SLOVENSKI STANDARD
SIST EN 60404-15:2013/A1:2017

Magnetic materials - Part 15: Methods for the determination of the relative magnetic permeability of feebly magnetic materials (IEC 60404-15:2012/A1:2016)

EN 60404-15:2012/A1

AMENDMENT 1
AMENDEMENT 1

**Figure 5 – Circuit diagram for the solenoid method
with reversing of magnetizing current**

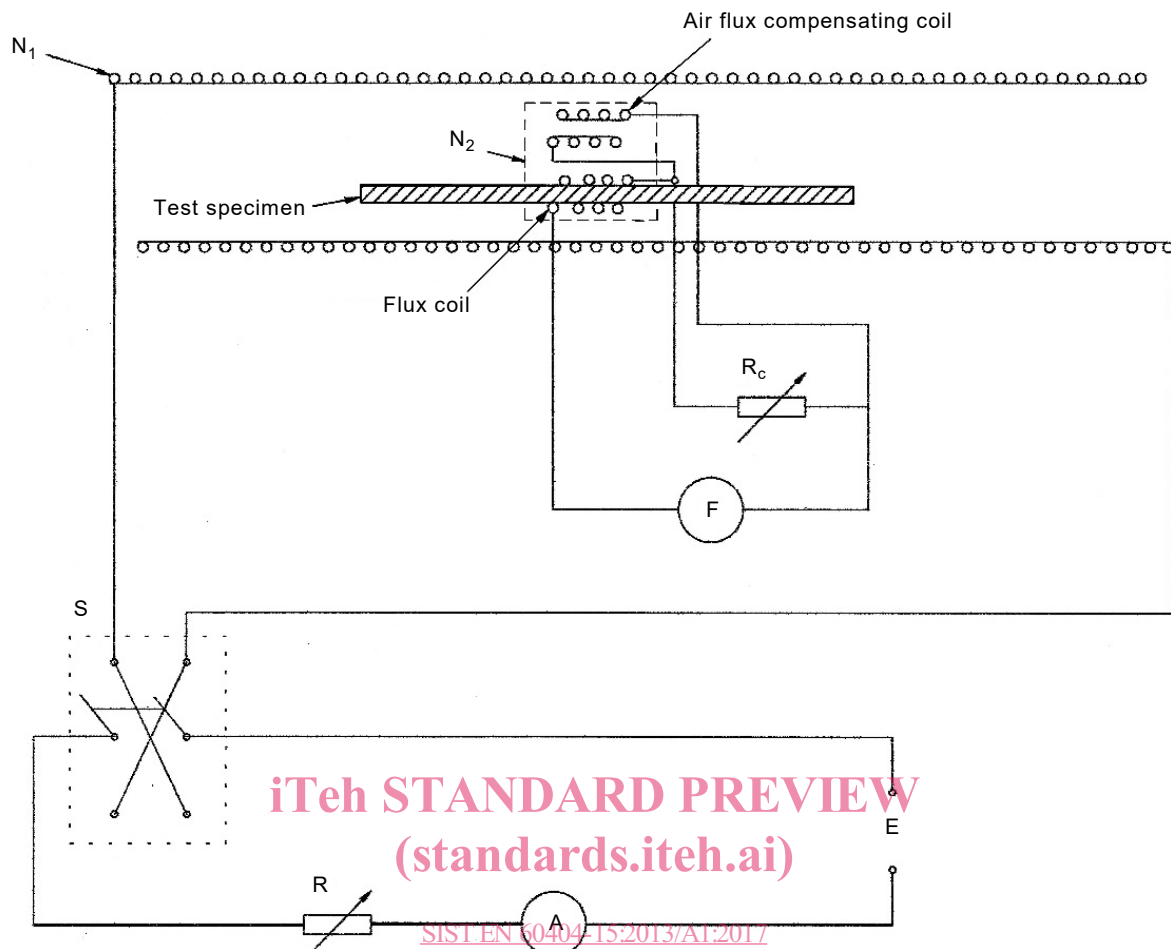
The relative magnetic permeability of a feebly magnetic test specimen is determined from the magnetic polarization J and the corresponding magnetic field strength H measured using the circuit shown in Figure 1 or Figure 5, using

Add a new Figure 5 with title and key, after Figure 1 and the note located below it, as follows:

Key

A   Current measuring device or ammeter

E   d.c. power supply

F   Flux integrator

N_1 Solenoid

N_2 Compensated search coil

R   Variable resistor (controlling magnetizing current)

R_c Variable resistor (to adjust the output of the air flux compensating coil)

S   Switch for reversing the current in the solenoid

The flux coil and the air flux compensating coil are connected in series opposition to form a compensated search coil. The length and effective area-turns of the flux coil and the air flux compensating coil shall be nearly equal, with the area-turns of the air flux compensating coil slightly larger than those of the flux coil so the compensating signal can be attenuated with a variable resistor (R_c in Figure 5) to match the signal from the empty flux coil.
